Title:       Advisory Committee on Reactor Safeguards  
              Subcommittee on ESBWR: Open Session

Date:                    Tuesday, July 13, 2010

**ESBWR Open Items:  
Containment Long-term Cooling (RAI 6.2-140)**

**ESBWR Open Items:  
Hydrogen Accumulation in PCCS (RAI 6.2-202):  
Evaluation of Detonation and DDT response of PCCS**

**Figure 3. PCCS vent line exit elevation used and GDCS pool water level predicted by TRACG (DCD Rev. 7) for MSLB (bounding case)**

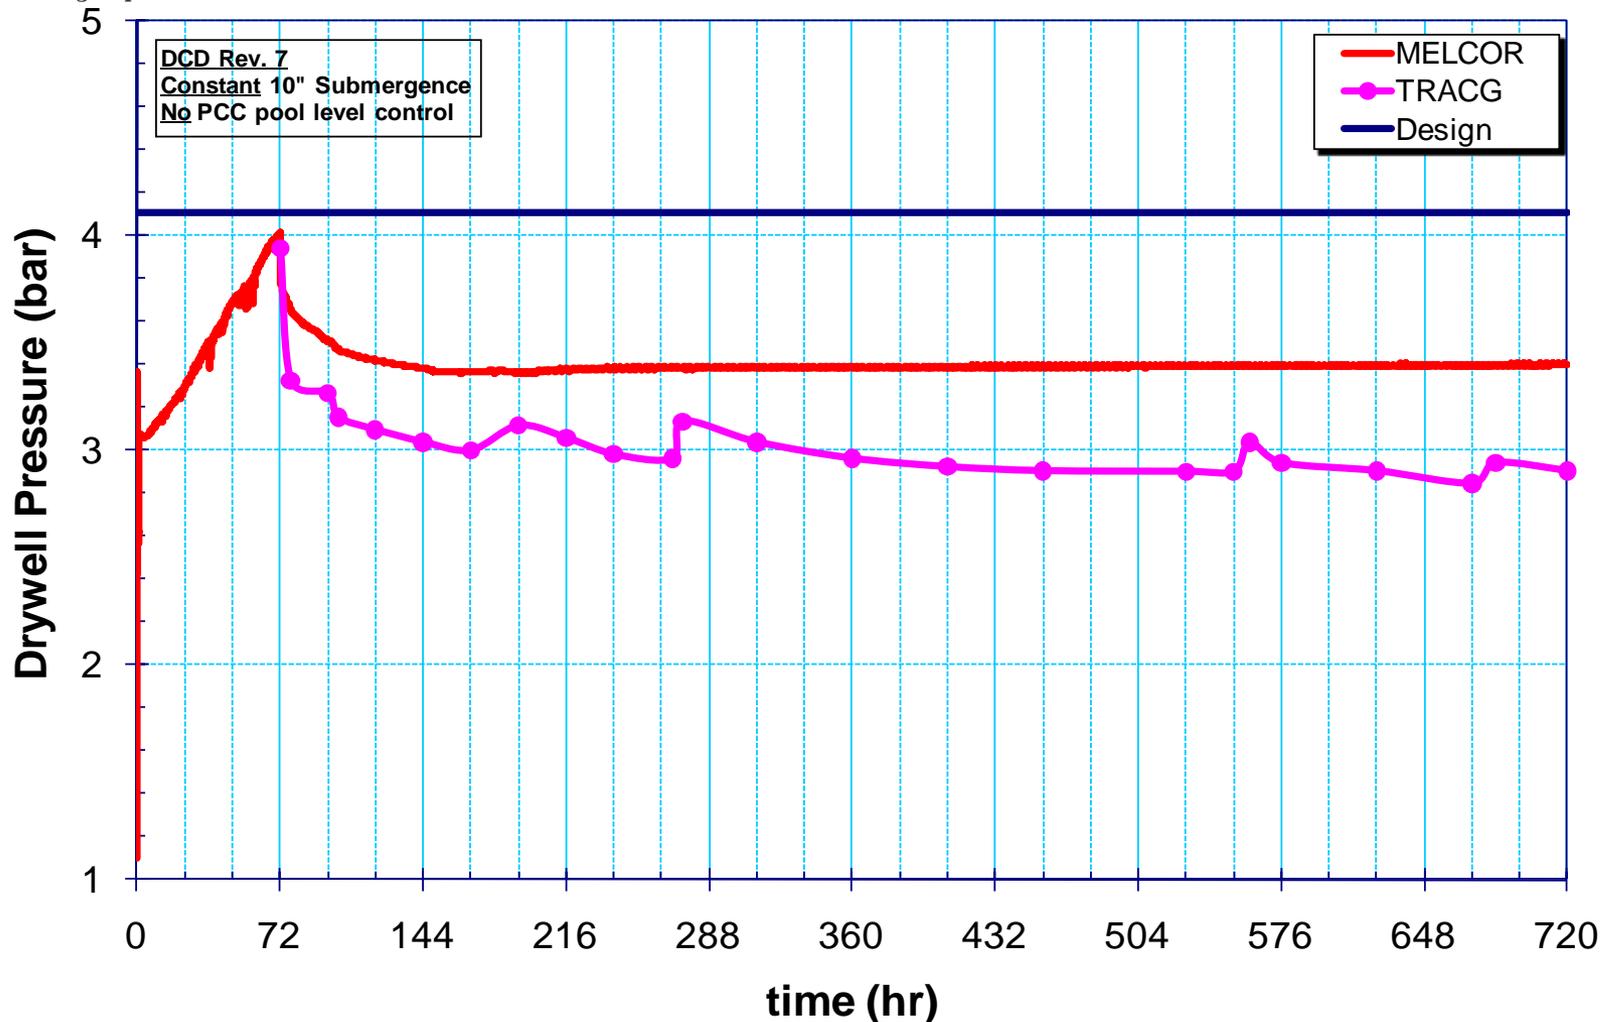
- ESBWR design-basis LOCA containment long-term pressure response calculated by TRACG, which is confirmed by staff's MELCOR analysis, is below the containment design pressure and is acceptable
- RAI 6.2-140 is closed

**Figure 1: Portions of PCCS Considered for Detonation**

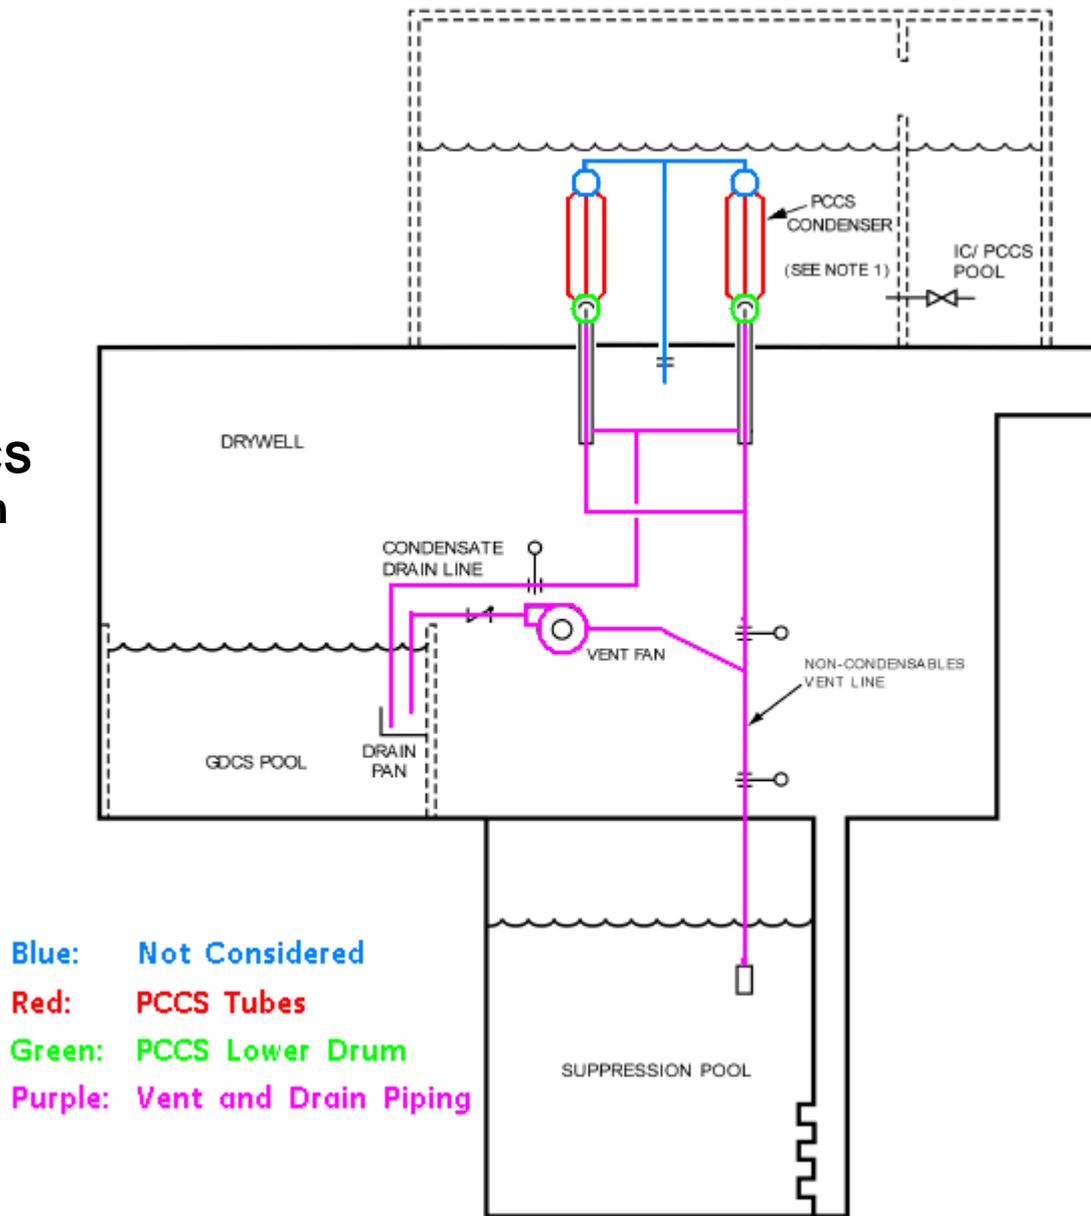
- **Detonation pressure loading in PCCS lower drum and drain and vent lines**
- **Modifications of lower-drum covers and drain nozzles to account for high stresses**
- **Detonation effects on PCCS components not directly exposed to detonations (e.g., anchorage, support frame, and pool slab penetrations)**
- **Fatigue evaluations for multiple detonations**
- **Design of ICS**

- GEH proposed to treat combustion as constant volume and take credit for venting through tubes.
- Mixture is very sensitive, cell size is very small relative to dimensions of drum and DDT cannot be ruled out.
- No analysis was done on efficacy of venting in preventing DDT – likely to be difficult to show
- Conclusion:

- **PCCS condenser tubing**
  - **Changed material from SA-213 Gr TP304L to SA-312 Gr XM-19**
  - **Increased thickness**
  - **Increased number of tubes per module (2 modules in each PCCS condenser)**
- **Increased thickness of lower drum and changed material to SA-182 Gr XM-19**
- **Added catalyst (platinum or palladium coated plates) to the vent in the lower drum of the condenser**
